Access Compliance Report Public Rights-of-Way (Curb Ramps)

Intersection ID: 54156 Main Street: OAKDALE RIDGE RD Cross Street: MAPLE CREEK CT Location: SW

ADA ID: 744FE3F796B1 Ramp Type: Perp Initial Pass/Fail: Fail Overall Compliance: No Severity Score: 8.75

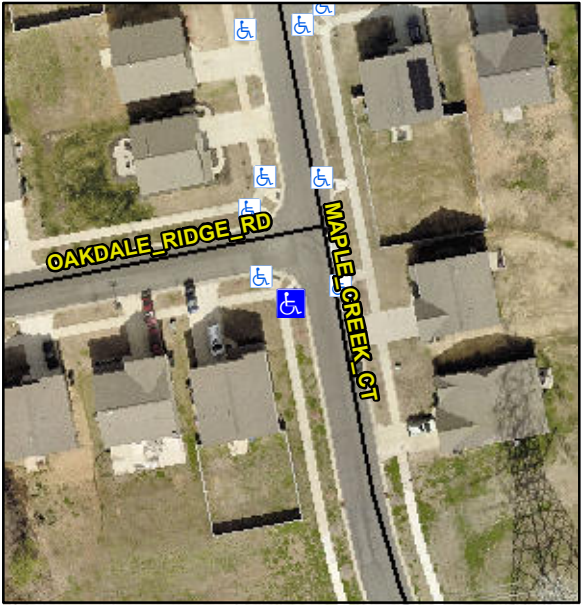
PROW/ADA:
R304.5.1

Compliance	Description	Data	Compliance	Description	Data
N/A	Ramp Length (in)	96.0	Yes	Ramp Slope (%)	6.8
No	Ramp Width (in)	46.0	Yes	Ramp XSlope (%)	0.3
N/A	Flare Type LT	N/A	N/A	Flare Type RT	N/A
N/A	Flare Slope LT (%)	N/A	N/A	Flare Slope RT (%)	N/A
N/A	Flare Traversable LT?	N/A	N/A	Flare Traversable RT?	N/A
N/A	Landing Length (in)	N/A	N/A	DWS Provided?	N/A
N/A	Landing Width (in)	N/A	N/A	DWS Contrast?	N/A
N/A	Landing Slope (%)	N/A	N/A	DWS Length (in)	N/A
N/A	Landing X Slope (%)	N/A	N/A	DWS Full Width?	N/A
N/A	Landing Curb? (Y/N)	N/A	N/A	DWS Offset (in)	N/A
N/A	Shared Landing?	N/A			
N/A	Gutter Ponding?	N/A	N/A	Gutter Slope (%)	N/A
N/A	Gutter Lip Ht (in)	1.0	N/A	Gutter X Slope (%)	N/A
N/A	Painted X Walk1?	No	N/A	Painted X Walk2?	N/A
	X Walk 1 Direction	To E		X Walk 2 Direction	N/A
N/A	X Walk 1 Width (in)	N/A	N/A	X Walk 2 Width (in)	N/A
	X Walk 1 Slope (%)	2.6		X Walk 2 Slope (%)	N/A
	X Walk 1 X Slope (%)	2.5		X Walk 2 X Slope (%)	N/A

Possible Solutions:
Remove & Replace Entire Ramp.
